**Validation report form for post-registration changes for
CDM project activities
(Version 02.0)**

Title and UNFCCC reference number of the project activity	São João Landfill Gas to Energy Project (SJ)Reference number 0373
Process track	<input checked="" type="checkbox"/> Prior approval <input type="checkbox"/> Issuance <input type="checkbox"/> Renewal of crediting period
Version number of the validation report on PRCs	4.0 Aa
Completion date of the validation report on PRCs	02/10/2019
Type(s) of PRCs	<input checked="" type="checkbox"/> Temporary deviations from the registered monitoring plan, applied methodologies or applied standardized baselines <input checked="" type="checkbox"/> Corrections <input type="checkbox"/> Changes to the start date of the crediting period <input type="checkbox"/> Inclusion of a monitoring plan <input checked="" type="checkbox"/> Permanent changes to the registered monitoring plan, or permanent deviation of monitoring from the applied methodologies, standardized baselines, or other applied standards or tools <input checked="" type="checkbox"/> Changes to the project design <input type="checkbox"/> Changes specific to afforestation and reforestation pro

Figure 1 – Methane generation from the landfill – estimated Vs. performed

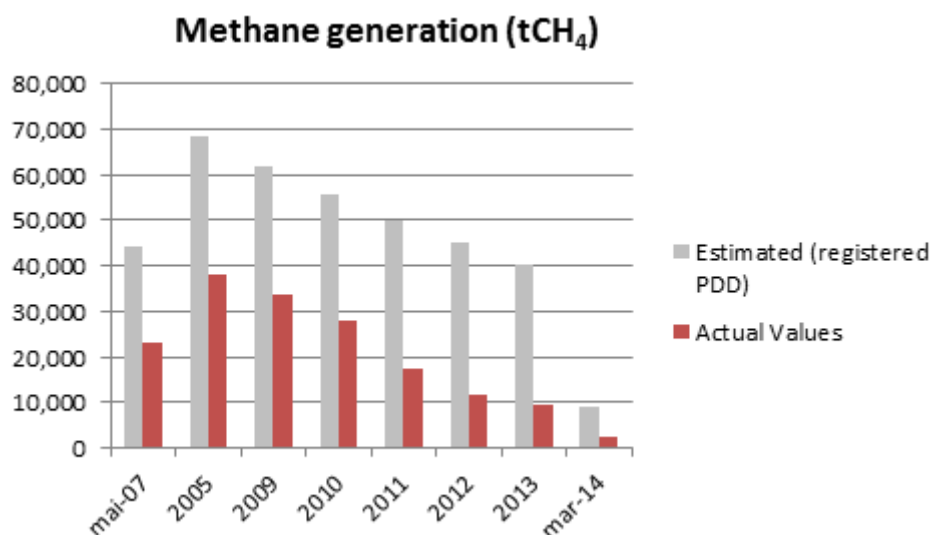
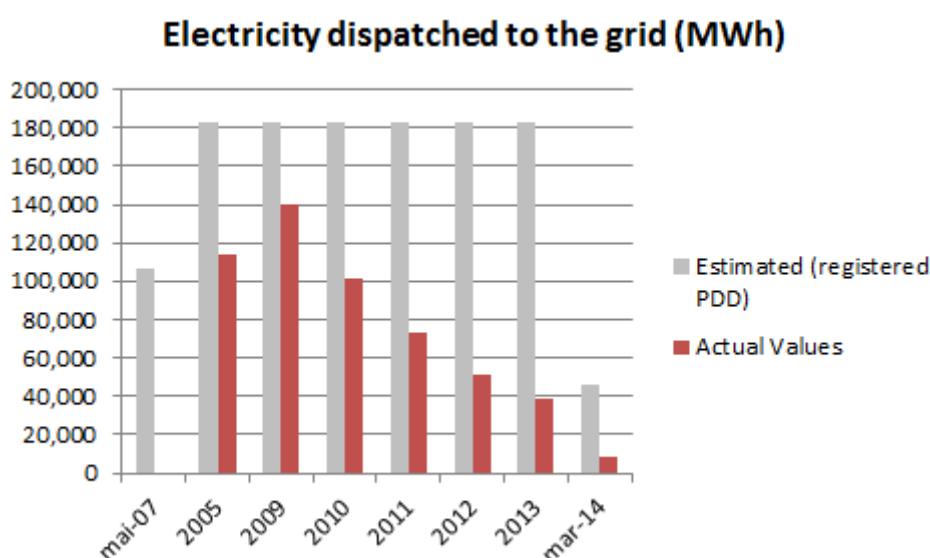
2) The DOE is requested to provide a validation opinion when the decrease of the production of the LFG were known which resulted in less generation of electricity and the change in the supply of LFG as per the VVS for PA paragraph 309(b).

As can be seen in the figures above, the project generated methane 56.3% lower than estimated in the registered PDD during the crediting period; regarding electricity generation, it generated 57.9% lower than estimated for the crediting period. Therefore, in 2013, the Project Participants decided to purchase LFG from CTL in order comply with the power purchase agreement and in April 2014 CTL started to provide LFG to SJEA. This change also impacted the CTL CDM project activity for which request for revision of PDD was approved by the Board in September 2018³.

Figure 2 – Boundaries of PA5947 (left) and PA0373 (right)

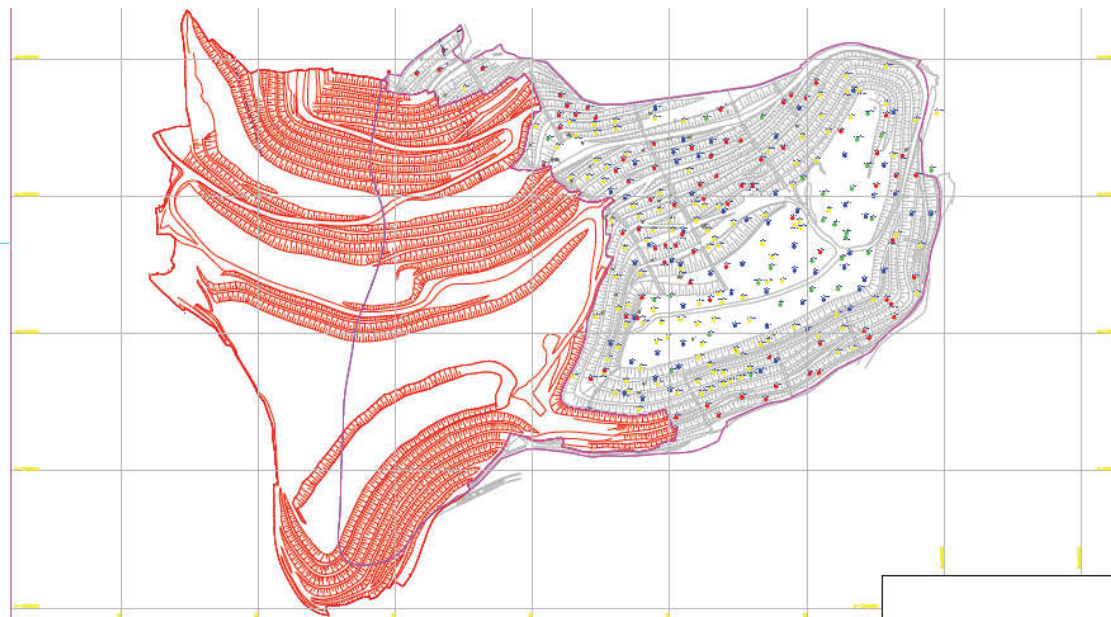
1. Considering that the power plant (25.6 MW) of the project activity (PA 373) is not located in the site of PA 5947, the DOE is required to further validate that the project boundary of project activity (PA 373) is in line with the paragraph 16.a of ACM0001 v18.1 which states that “The project boundary of the project activity shall include the site where the LFG is captured and, as applicable: (a) Sites where the LFG is flared or used (e.g. flare, power plant, boiler, air heater, glass melting furnace, kiln, natural gas distribution network, dedicated pipeline or biogas processing facility)”. In doing so, please also provide the exact geo-coordinates for the project activity. Geographical coordinates presented in the PDD of PA5947 and PA0373 are based on the power plant location of both projects.

As can be seen in figure 2, PA5947 is next to PA0373; in the left side is CTL's SWDS (PA5947) and in the right side is SJE's SWDS (PA0373). São João landfill is closed since 2009 and CTL landfill started operation in November 2010 considering a new SWDS area. According to PA5947's PDD, CTL's landfill is expected to resume operation in 2021, considering the current filling rate. Figure 1 is included in the PDD (section A.2).

It is worth mentioning that both landfills - PA0373 and PA5947, are independent and materially separated projects and operate fully segregated cells.

Figure 4 of the PDD presents the diagram of the project boundary, which does not include the LFG from CTL landfill (PA5947). In fact, ACM0001 v18.1 establishes that “LFG shall include the LFG is captured”, however LFG from PA5947 is not used for emission reductions purposes and, therefore, the SWDS of PA5947 is not included in PA0373 project boundary.

Figure 3 – Example of mass balance

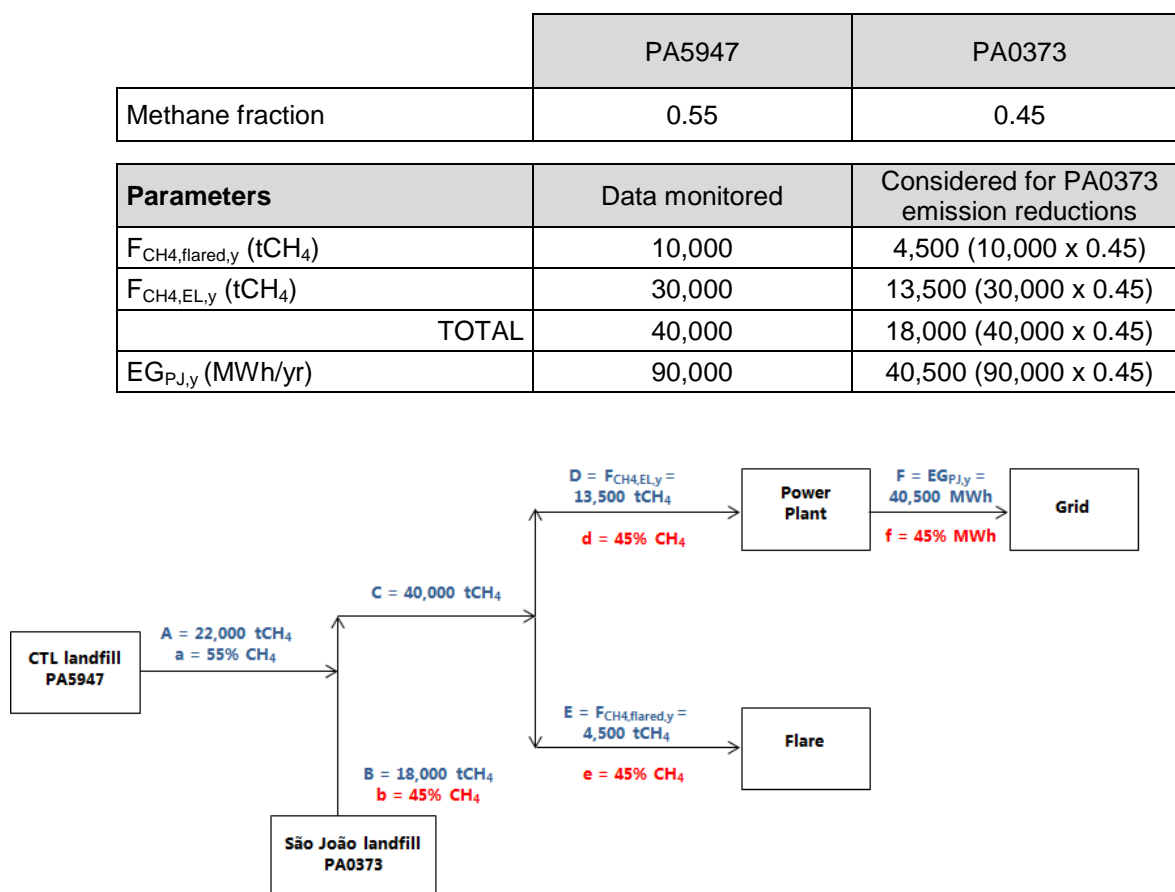
2. The revised PDD of PA 373 (page 2-3) states that “CTL is a CDM project (# 5947) and, as described in its registered PDD and Validation Report, all emission reductions generated from the biogas produced by CTL project is of CTL’s right and will be claimed by them. SJ will not claim CERs from this biogas.” The DOE is requested to clarify how it validates all emission reduction generated from the biogas produced by PA 5947 is not claimed by the project activity (PA 0373) as:

- the monitoring plan (PA373) does not clearly show the monitoring of LFG supply from PA 5947 used for electricity generation and/or flaring; and
- emission reductions from electricity generated using LFG supply from PA 5947 is accounted in the emission reductions calculations as the revised PDD (PA373), validation report for the PRC and the spreadsheet (Baseline emissions sheet – cell D48 corresponding to data up to 21/05/14) do not separate the emission reductions obtained from the electricity generated due to the LFG supplied by PA 5947.

LFG production at PA5947 is not controlled by PA0373, but LFG purchased from PA5947 is fully monitored, and is not accounted in PA0373's CERs calculation. As described in the PDD (sections B.2, B.6.1, B.7.3 and appendix 7.), PA0373 emission reductions will be calculated by applying discounts on readings proportionally to CH₄ mass balance from LFG purchased from CTL. Follows an example calculation:

PDD section B.6.1 and B.7.1 was revised to make it clear that PA0373 baseline emissions due to CH₄ and electricity generation will only be accounted for the mass proportion of SJ's methane from total emissions.
